Software Release Note

RD-002-05

Project Title: EKO / e24 / TEKO Dimmer

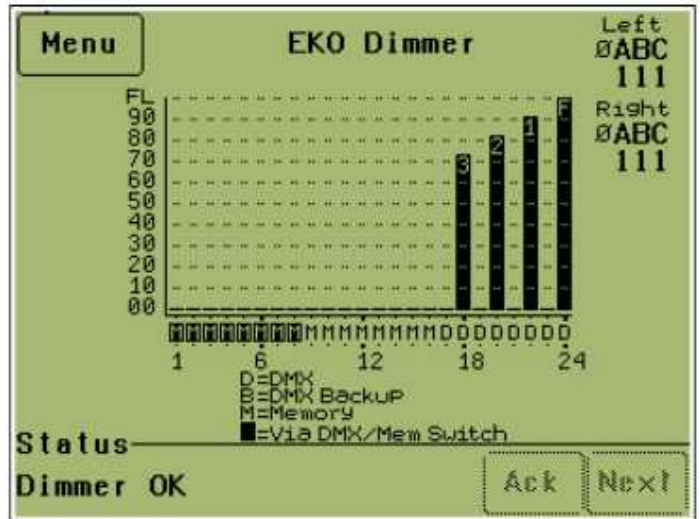
- DMX/Mem Switch Terminology .
What was previously known as the Mem/DMX switch is now known as the DMX/Mem switch. This reflects its usage priority in most installations.

- Dimmer Channel Source is shown below Bargraph on Status Screen.
The channel source is shown as either

- D : DMX
- B : DMX Backup
- M : Memory

If the channel source is via the DMX/Mem switch the source text is shown as inverted text.

In the example above channels 1 to 8 are switched via the DMX/Mem switch, which is currently switched to Memory source. Channels 9 to 17 are sourced from Memory. Channels 18 to 24 are sourced from DMX, which is connected.

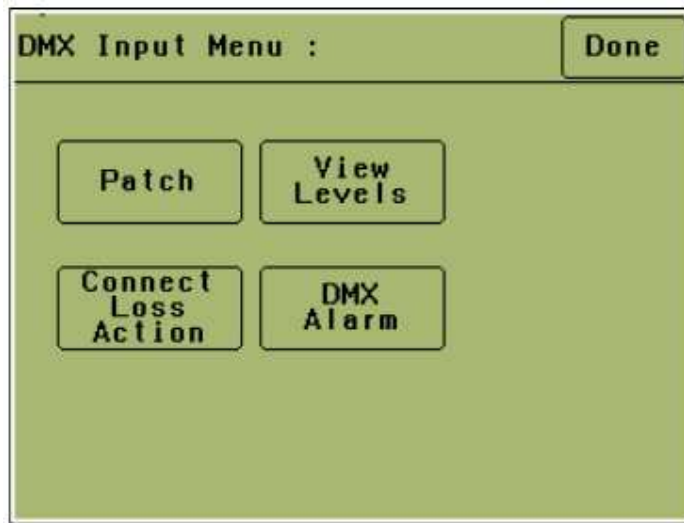
- The channel setup menu has been reworked.

All channel properties can now be viewed and manipulated in the Channel Setup menu. These are: Control Source, Min Level, Max Level, Fade Curve, Net Master Group.

Net related functions are not shown if LSCNet is disabled, and disabled if Net Playback is disabled.

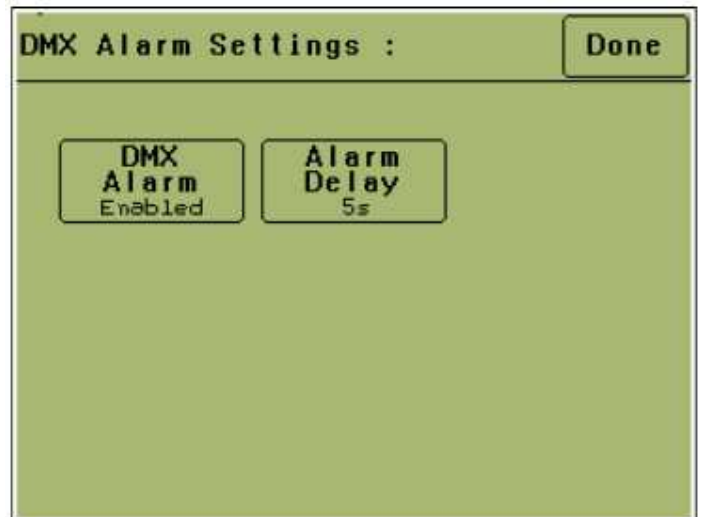
- The DMX Input Menu has been simplified and consolidated.
All functions directly relating to DMX have been placed in the DMX Input Menu.

- DMX Alarm**
The DMX Alarm can be enabled, disabled from here, and the alarm delay can be set. For further details refer to the manual.

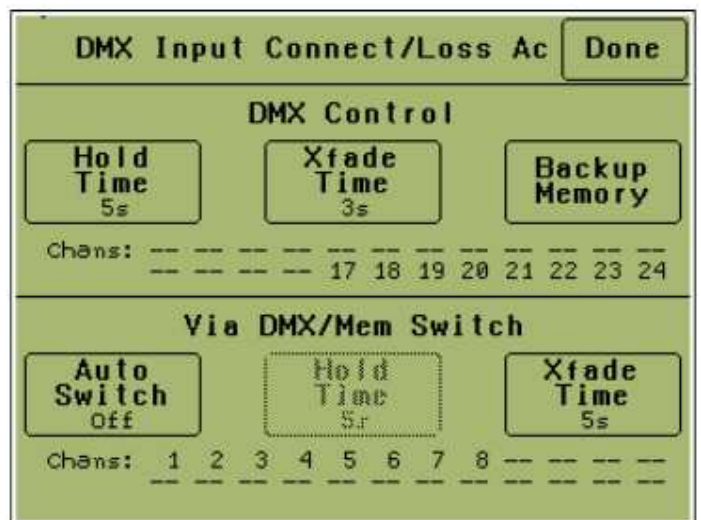
- The Connect/Loss action menu appearance will depend on whether or not LSCNet is enabled, and whether or not Net Playback is enabled. If both are enabled it looks like this:

The Hold Time, Xfade Time may be set for the DMX Control Source.

The Auto Switch function, Hold Time and Xfade Time may be set for DMX control via the DMX/Mem switch.
